ROTACOD

EM58 • HS58 • HM58 Ethernet

Carrè, 20.03.2023
Our ref.: NPC23003 Ethernet encoders

EM58, HS58 & HM58 Ethernet encoder series

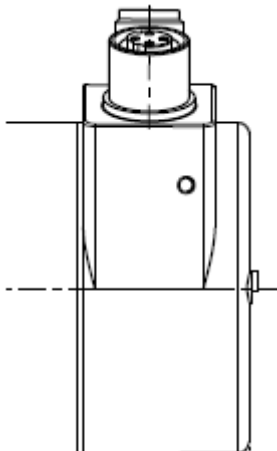
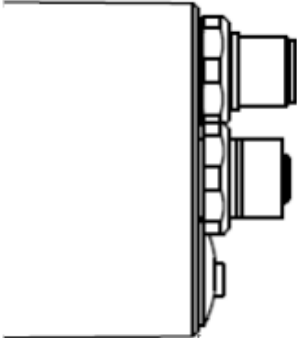
Description of Change

Lika has 3 encoder series with several Ethernet interfaces, such as Profinet, Ethernet/IP, EtherCAT, Powerlink and Modbus-TCP. All 3 series are equipped with an Ethernet module/component which is encountering heavy delivery problems since 2022 and reduced availability to cover approx. only 10% of our demand.

This situation has forced Lika to design-in an alternative component and in the meantime introduce other improvements to develop the next generation Ethernet encoder families.

The main advantages of the new EXM58 and EXO58 series are:

- compact design and axial connectors
- energy harvesting multiturn technology
- improved Ethernet interface performance

[Type of change] Description	Before	Now
[Order code change] Order codes EM58 series	EM58 EM58S EMC58, EMC59	EXM58 EXM58S EXM58C, EXM59C
[Order code change] Order codes HS58 series	HS58 HS58S HSC58, HSC59	EXO58 EXO58S EXO58C, EXO59C
[Order code change] Order codes HM58 series	HM58 HM58S HMC58, HMC59	EXO58 EXO58S EXO58C, EXO59C
[Mechanical interface change] Fixing plate style "xx60"	EMC60, HSC60, HMC60	will be replaced by xxx59C + KIT xx60 (kit of fixing plate and screws) Customer will need to mount the fixing plate on his own. Mechanical compatibility is 100%
[Mechanical interface change] Connector position

Mechanical interface change] Overall dimensions	see attached datasheet CAT EM58_HS58_HM58 Ethernet E	see attached datasheet CAT EX058_EXM58 E preliminary
[Mechanical interface change] Shaft length	EM58S, HS58S, HM58S shaft length is 16 mm (this change does not apply to other types)	EXM58S, EX058S shaft length is 20 mm (this change does not apply to other types)
[Software configuration] Installation files	---	New installation files for EXM58 and EX058 will be created and replace those for EM58, HS58, HM58 series
